**TOWN OF BAY HARBOR ISLANDS  
MORRIS N. BROAD COMMUNITY CENTER  
1175 95TH STREET  
BAY HARBOR ISLANDS, FL 33154**

**MEETING OF THE DESIGN REVIEW BOARD**

**March 4, 2025  
7:00 PM**

**Subject:** Site Development Plan Application  
Bay Harbor Luxury Townhomes - 5 DU Complex  
9761 West Bay Harbor Drive  
Bay Harbor Islands Acct. No. SPR2024-000021  
MMPA Acct. No. 01-0702-1196

**PHOTOMETRIC PLAN**

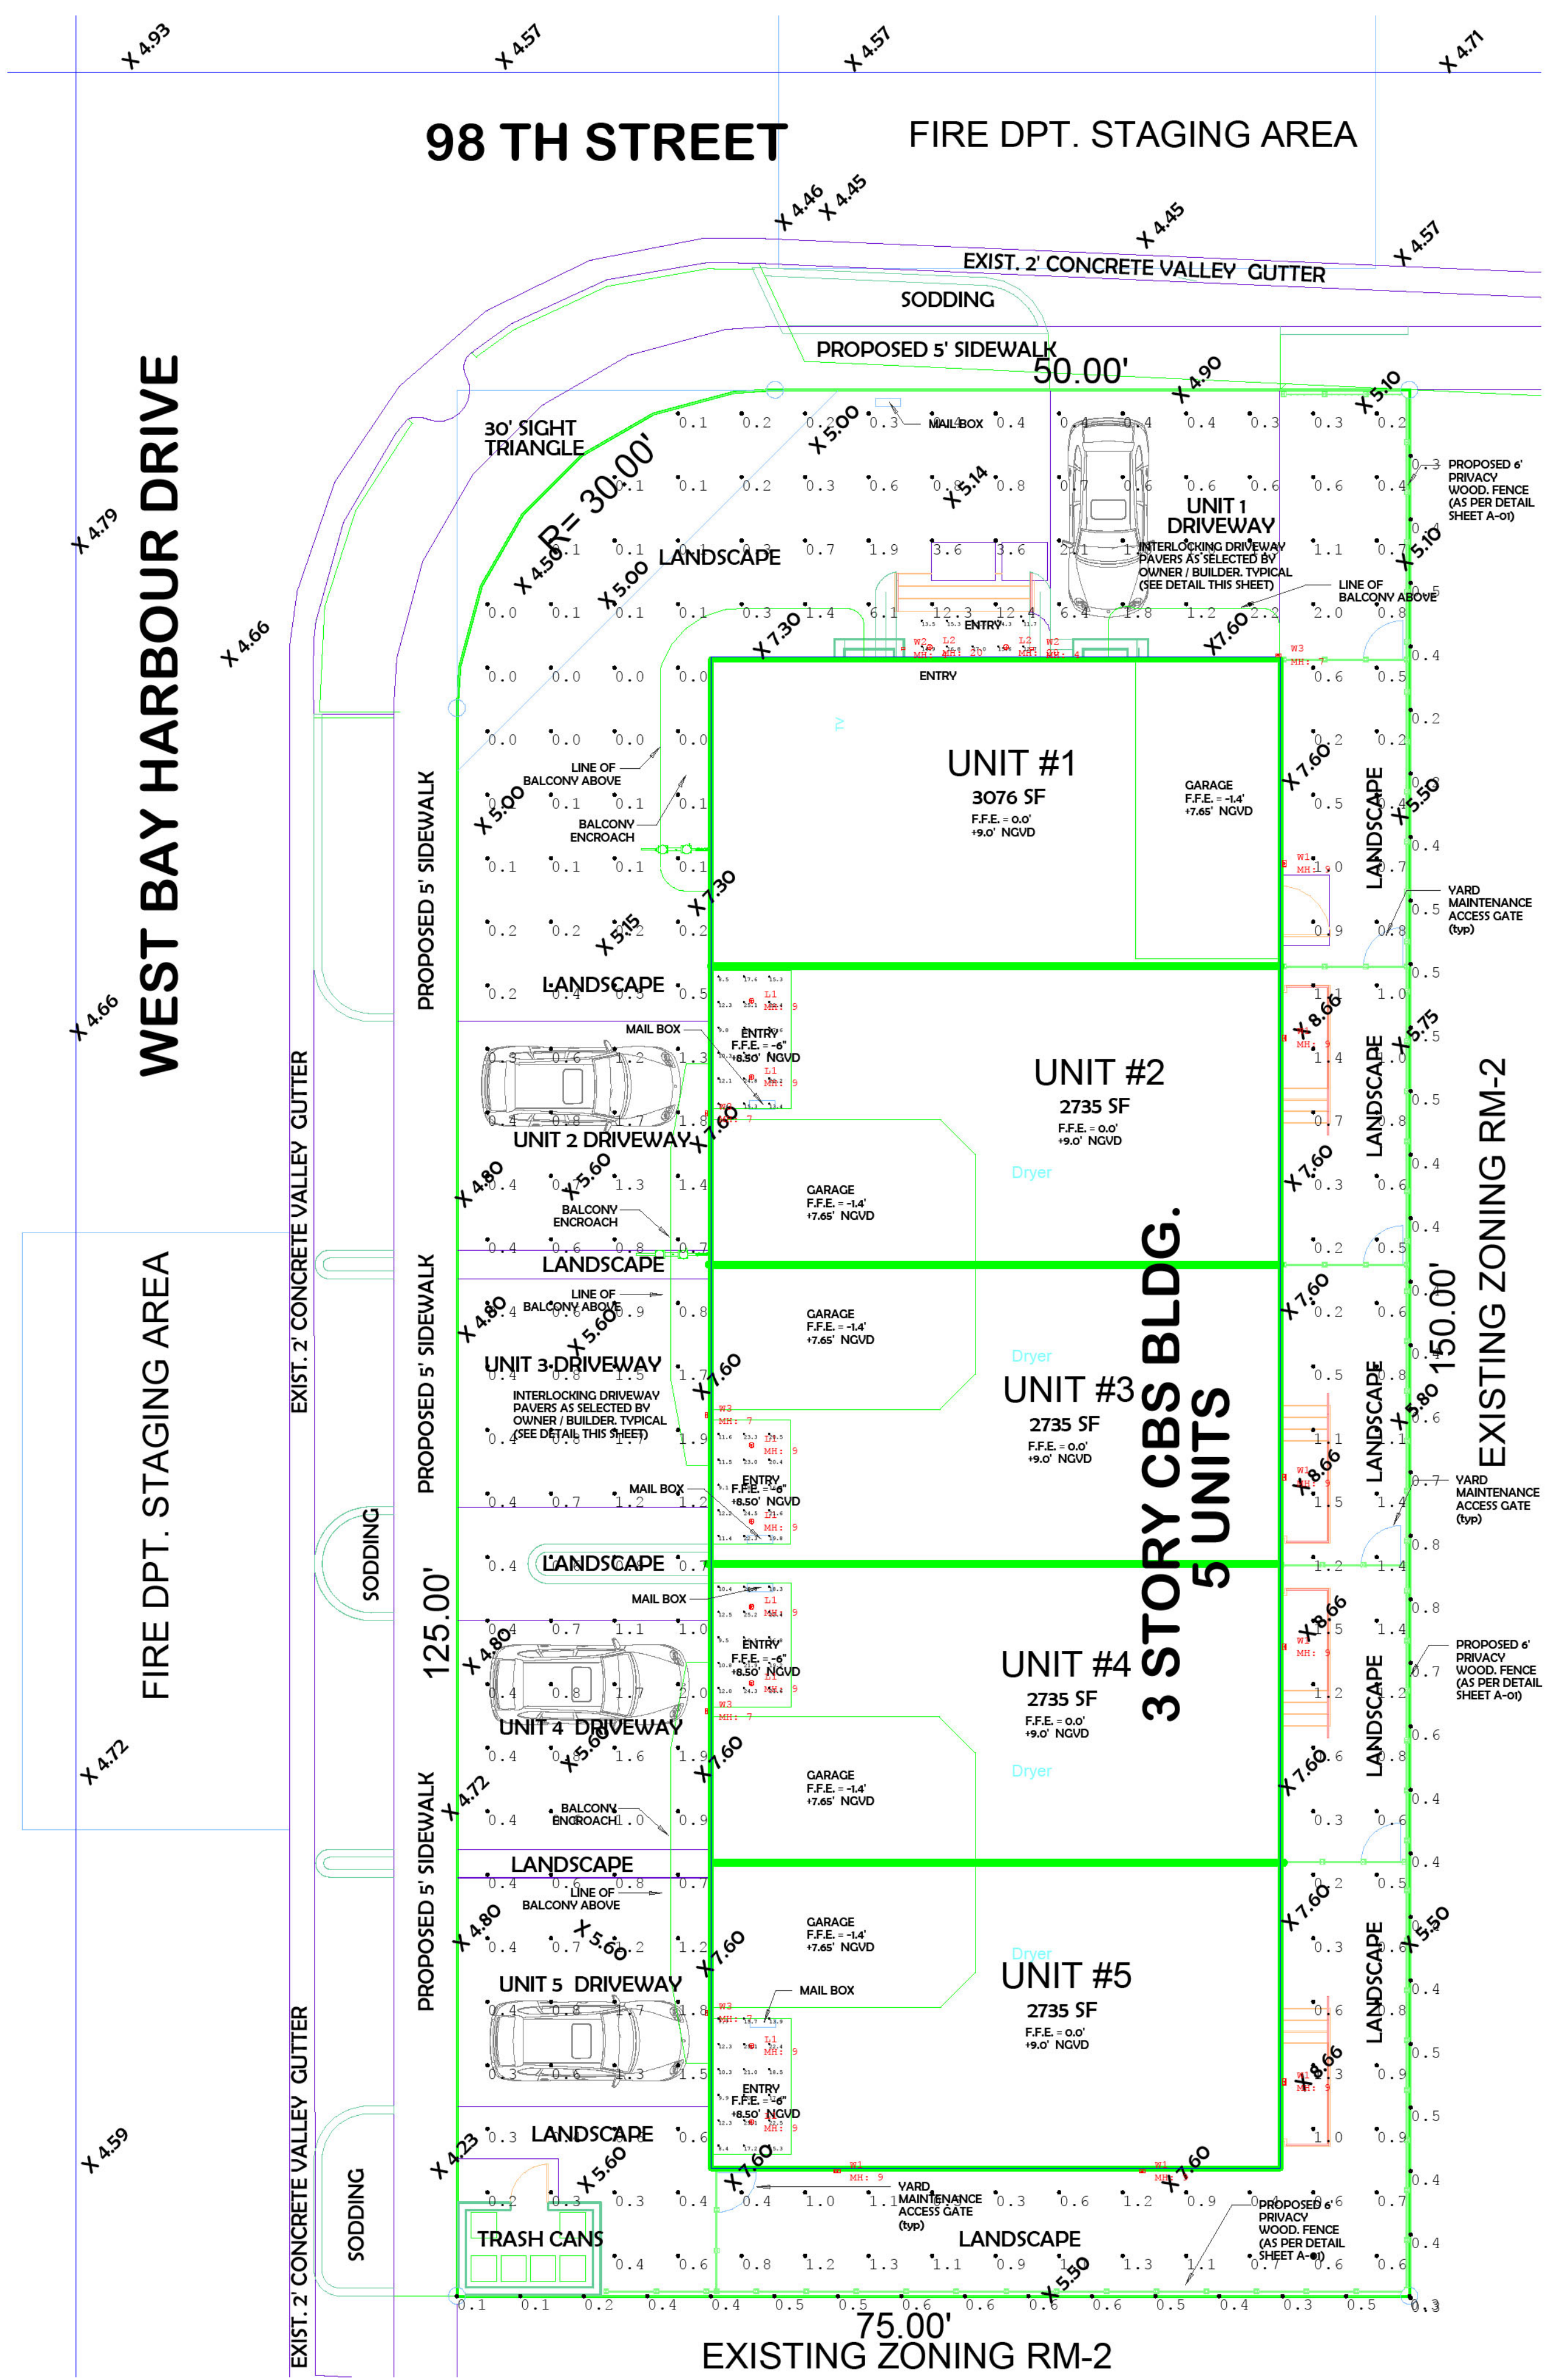
2. Outdoor Lighting Plan - The preliminary Photometric Lighting Plan shows general compliance with the Town's Exterior Lighting Code requirements found in Sec. 23-19. At the time of building permit review the Town staff will ensure the final lighting plan complies with the Code footcandle limitations / requirements.
